JAMES A. FITZPATRICK NUCLEAR POWER PLANT

AMENDMENT TO FACILITY OPERATING LICENSE

Amendment No. 113
License No. DPR-59

ATTACHMENT TO LICENSE AMENDMENT NO. 113

FIGURE 3.6-1
 REACTOR VESSEL PRESSURE - TEMPERATURE LIMITS

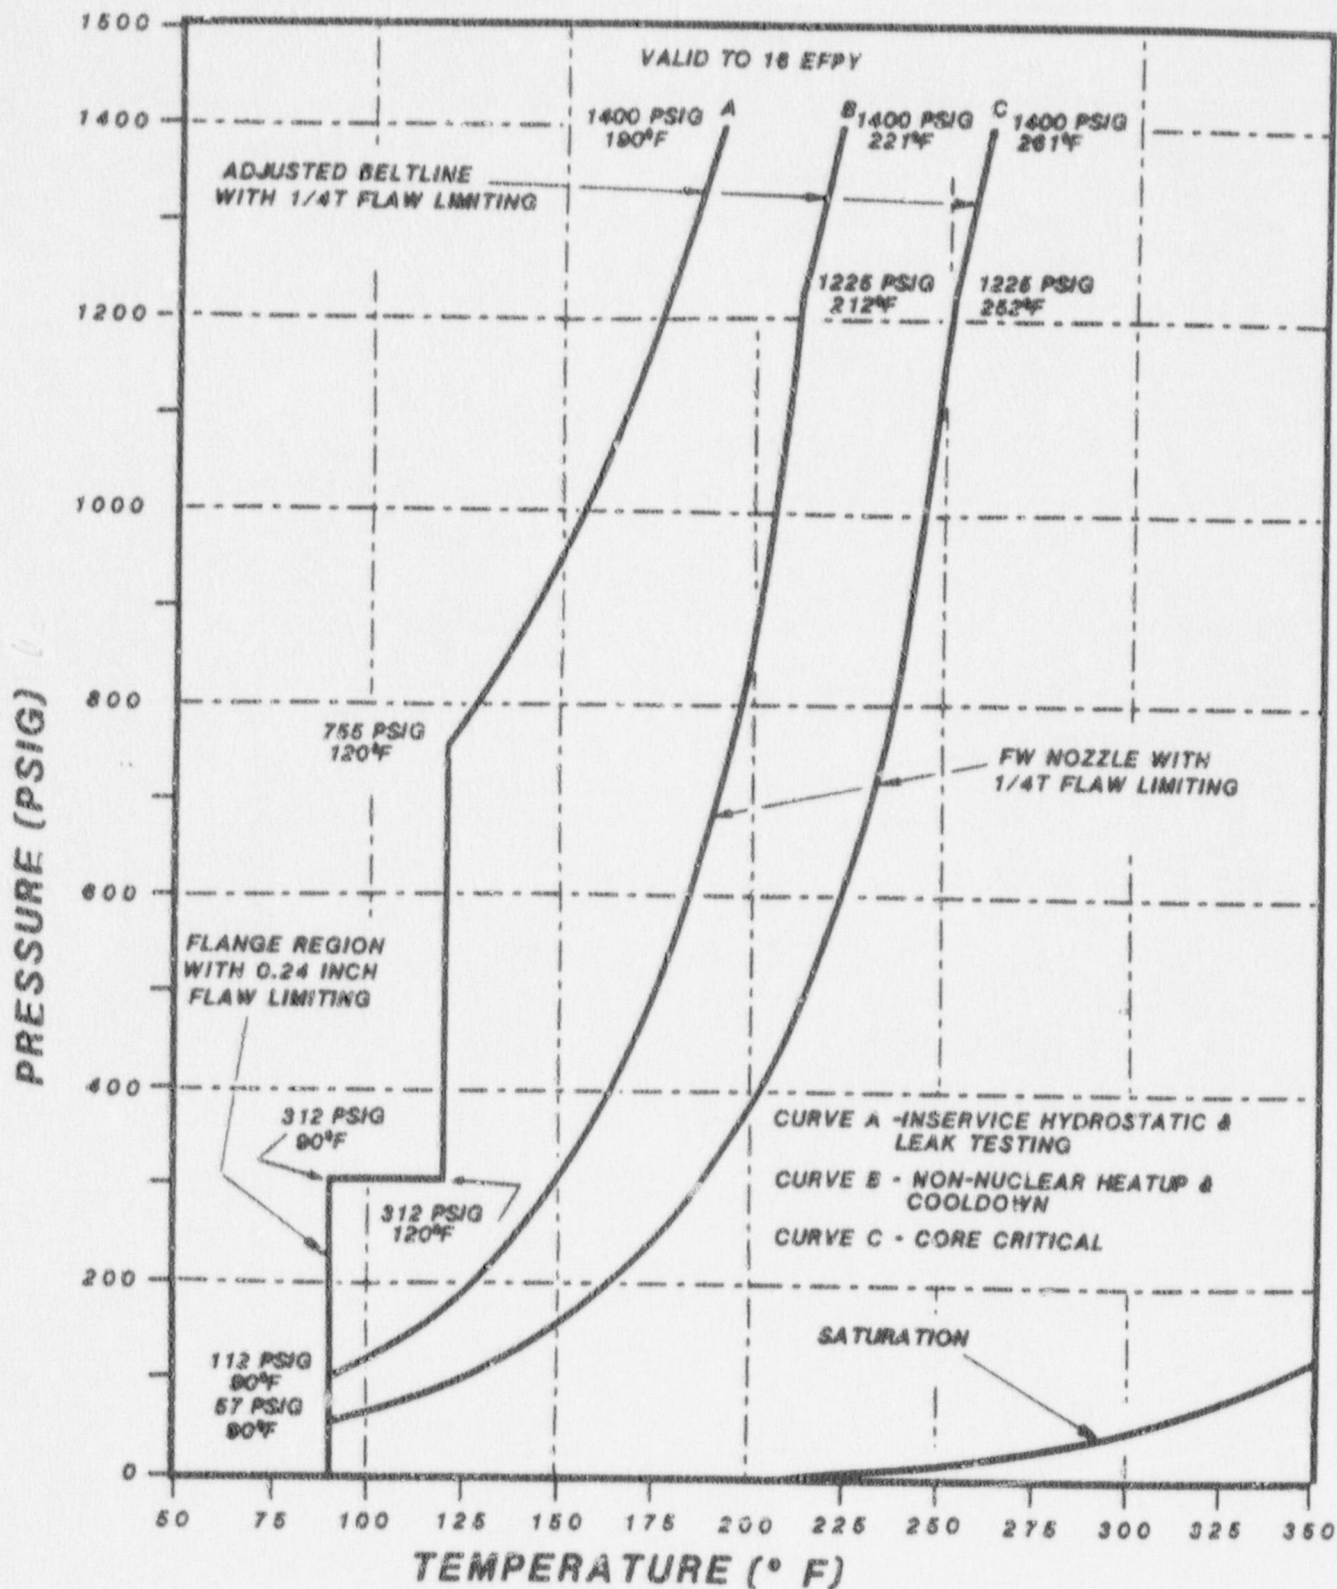
The first surveillance capsule containing test specimens was withdrawn in April, 1985 after 6 EFPY. The test specimens removed were tested according to ASTM E 185-82 and the results are in GE report MDE-49-0386. The curves of Figure 3.6-1, A through C, reflect findings in the report related to copper-phosphorus content of the reactor vessel shell beltline, flux wire testing fluence distribution analysis, and Charpy V-Notch specimen testing. The next surveillance capsule will be removed after 15 EFPY of operation and the results of the examination used as a basis for revision of Figure 3.6-1 curves A, B and C for operation of the plant after 16 EFPYs.

Figure 3.6-1 curve A establishes the minimum temperature for hydrostatic and leak testing required by the ASME Boiler and Pressure Vessel Code, Section XI. Test pressures for in-service hydrostatic and leak testing are a function of the testing temperature and the component material. Accordingly, the maximum hydrostatic test pressure will be 1.1 times the operating pressure or about 1105 psig.

Figure 3.6-1, curve B, provides limitations for plant heatup and cooldown when the reactor is not critical or during low power physics tests. The thermal limitation is based on maximum heatup and cooldown rates of 100°F/hr in any one-hour period.

Figure 3.6-1, curve C, establishes operating limits when core is critical. These limits include a margin of 40°F as required by 10 CFR 50 Appendix G.

The requirements for cold boltup of the reactor vessel closure are based on NDT temperature plus a 60°F factor of safety. This factor is based on the requirements of the ASME Code to which the vessel was built. For Figure 3.6-1, curves A, B and C, 60°F margins are only added to the low temperature portion of the curve where non-ductile failure is a concern. The closure flanges have an NDT temperature not greater than 30°F and are not subject to any appreciable neutron radiation exposure. Therefore, the minimum temperature of the flanges when the studs are in tension is 30°F plus 60°F, or 90°F.

During in-service hydrostatic or leak testing the Reactor Coolant System pressure and temperature shall be on or to the right of curve A shown in Figure 3.6-1 and the maximum temperature change during any one hour period shall be:

During heatup by non-nuclear means (mechanical), cooldown following nuclear shutdown and low power physics tests the Reactor Coolant System pressure and temperature shall be on or to the right of the curve B shown in Figure 3.6-1 and the maximum temperature change during any one hour shall be $\leq 100^\circ\text{F}$.

During all modes of operation with a critical core (except for low power physics tests) the reactor Coolant System pressure and temperature shall be at or to the right of the curve C shown in Figure 3.6-1 and the maximum temperature change during any one hour shall be $\leq 100^\circ\text{F}$.
